From: [Mark Ayranto](#)
To: [John.Minder](#)
Cc: [Millie Olsen](#); [Briar.Young](#); [Roger.Lockwood](#)
Subject: [EXT] RE: VGC Water Licence QZ14-041 MWTP cyanide destruction requirements
Date: November 29, 2022 2:51:02 PM
Attachments: [image001.png](#)

Re: Mine Water Treatment Plant and Cyanide Destruction: WUL QZ14-041

SCHEDULE A – RESPONSE TO REQUEST FOR ADDITIONAL INFORMATION

**Re: Mine Water Treatment Plant and cyanide destruction requirements of Water Licence
QZ14-041**

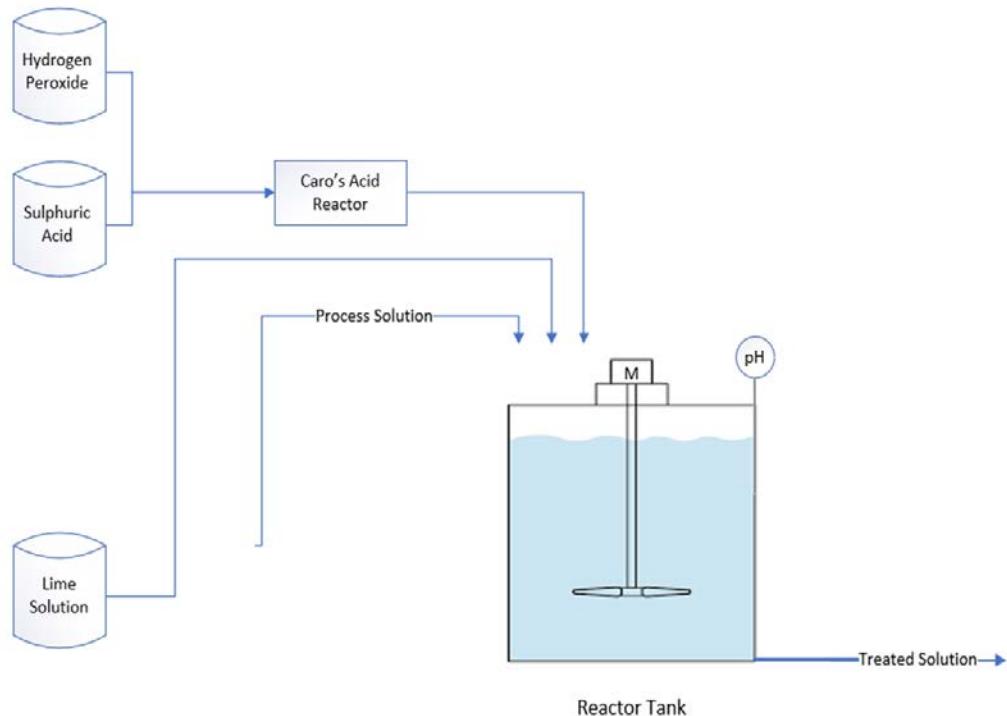
1. Describe in detail the method, design, and location of the cyanide destruction system to be operational prior to HLF Phase 2 and explain how it is consistent with water licence requirements.
2. Provide a clear timeline for the process of activating the cyanide destruction system to when needed to treat HLF solution in an emergency situation.
3. Identify when the MWTP will be commissioned and describe how it will be capable of supporting the cyanide destruction system with treatment of HLF solution to meet all effluent quality standards.
4. Identify the operational timing of ore loading and application of cyanide solution on HLF Phase 2.

1. Cyanide destruction will be completed using the Caro's acid process. Caro's acid or peroxymonosulfuric acid (H_2SO_5) is produced by reacting sulfuric acid (H_2SO_4) with hydrogen peroxide (H_2O_2). Caro's acid is not stable for long periods and thus it is produced on as needed basis by introducing hydrogen peroxide through a first feed line into a first reactor conduit and sulfuric acid through a second feed line into a second reactor conduit independently into a baffled, plug flow mixing reactor. This configuration is known simply as a Caro's Acid Reactor and is commonly used to breakdown cyanide

The pH of the process is controlled by the addition of lime to ensure that a pH range of 9-11 is maintained.
